Integration of Spectrometer FS BDAs:
alignment issues

Ref: SPIRE-RAL-NOT-
002661

By: Marc Ferlet (RAL)

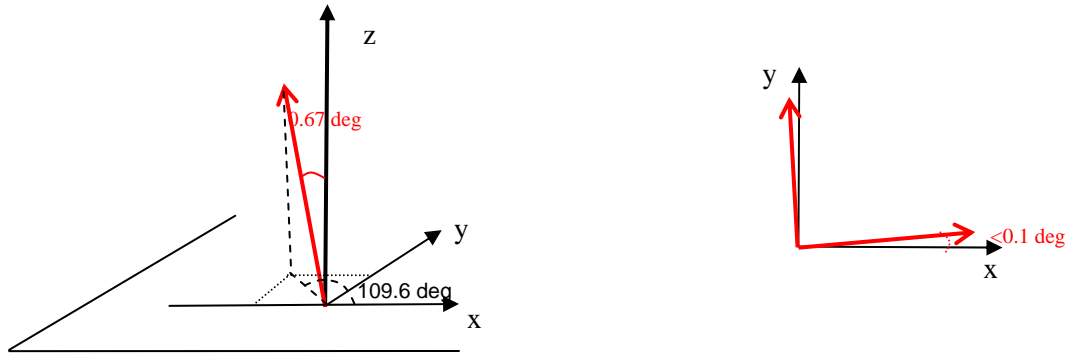
The measured tilt of the as-built x-y plane compared to the nominal one is found at ambient to be 0.67° wrt the local z axis. Additional no repeatable -0.09° rotation about x is quoted in RD1 when cryo-cycling. The additional cryo-cycle dependent tilt error is small compared to the nominal large tilt

offset which is larger than the acceptable limit of $\pm 30 \text{ arcmin} = \pm 0.5 \text{ deg}$ tolerances around the gut ray (nominally is aligned with the local z axis at the centre of the array).

The in-plane rotation has been found (ambient + cold) to be $0.08 \pm 0.04 \text{ deg}$ which is within the specifications of 0.293 deg ($= 17.6 \text{ arcmin}$ stated in RD3). This should not affect significantly the chop & jiggle pattern (the “smile” pattern in RD3).

From considerations above, it is suggested to correct for SSW and SLW tilt (not in-plane rotation) as values are not within specifications. **For SSW and SLW, it is suggested to compensate at interface plate level the global large tilt in the yz plane by a positive rotation of 0.5 deg about local +x only (for simplification instead of about a generally rotated axis in the xy plane inducing a more complex).** This will bring the tilt of SSW and SLW BDAs within the maximum allowed specification.

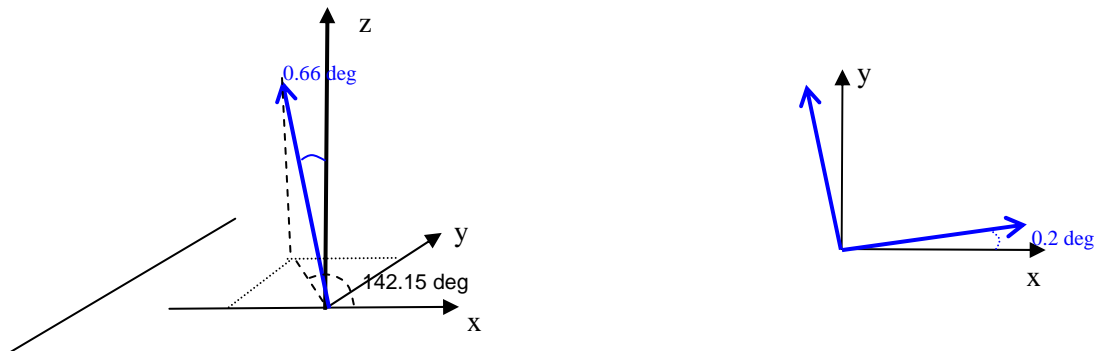
The measured tilt of the as-built x-y plane compared to the nominal one is found at ambient to be 0.66 deg wrt the local z axis with additional 0.03 deg non repeatable rotation about x during cryo-cycle. The additional cryo-cycle dependent tilt error is small compared to the nominal large tilt offset which is larger than the acceptable limit of $\pm 30 \text{ arcmin} = \pm 0.5 \text{ deg}$ tolerances around the gut ray (nominally is aligned with the local z axis at the centre of the array).

The in-plane rotation has been found (ambient + cold) to be 0.2 deg which is within the specifications of 0.293 deg ($= 17.6 \text{ arcmin}$ stated in RD3). This won't affect significantly the chop & jiggle pattern (the “smile” pattern in RD3).

Figure 1 (excerpt from ICD dwg 10209721, with coordinate axes shown)

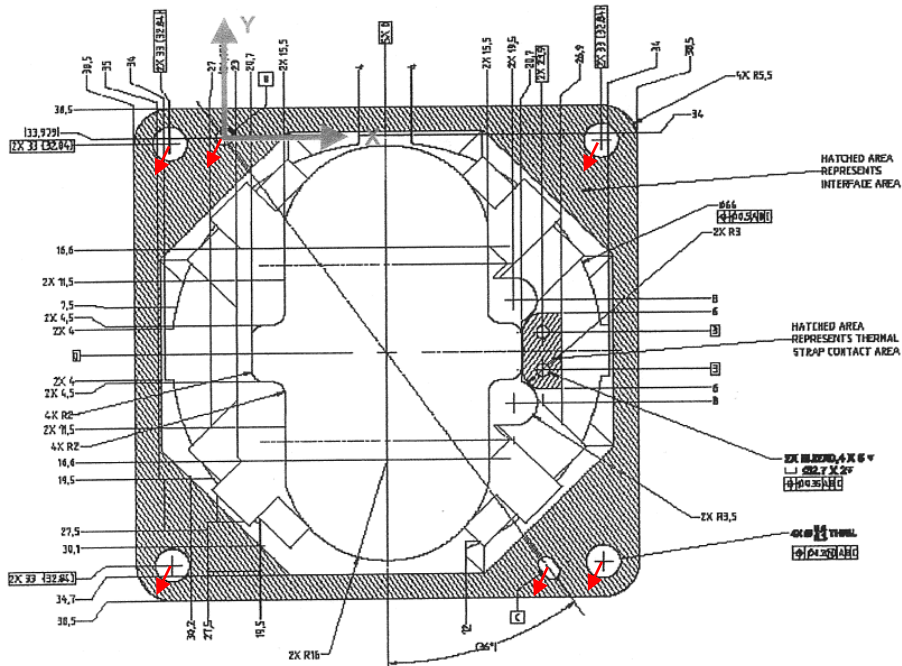
- SLW interface: Only the in-plane (local x-y) lateral shift needs to be corrected, by shift of the mounting holes in the interface plate with detector box in the following way:

Displacement of the mounting and reference points in the SLW interface plate wrt their nominal position by: (-100) μ m in x and (-200) μ m in y (axes x and y), as sketched below (red arrows).

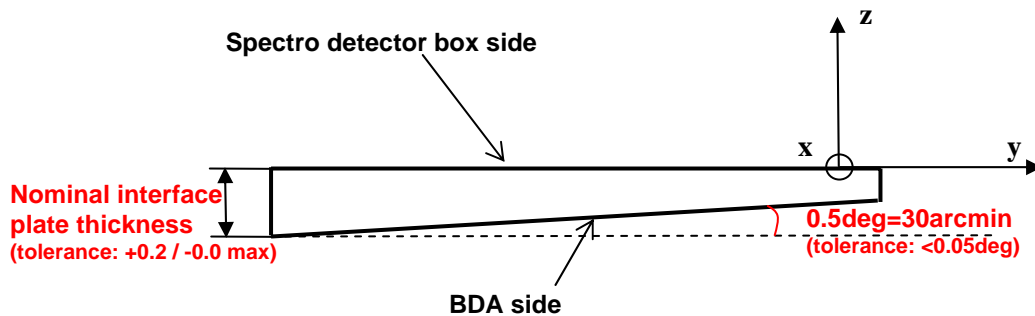
- **For SSW and SLW:** The alignment data regarding the FS SSW and SLW BDAs indicate a large tilt offset beyond specifications. **It is proposed here to compensate for it via a wedge interface plate as shown below in the cross-section diagram.**

NB: the removal of material from the nominal constant thickness interface plate will produce an axial shift along +z which is estimated to be of the order of +200-250 μ m max (suggested tolerance above

tuned to minimise this). Added to the above nominal expected BDA internal defocus along z, the net result will still be well within the allocated +/-0.5mm.
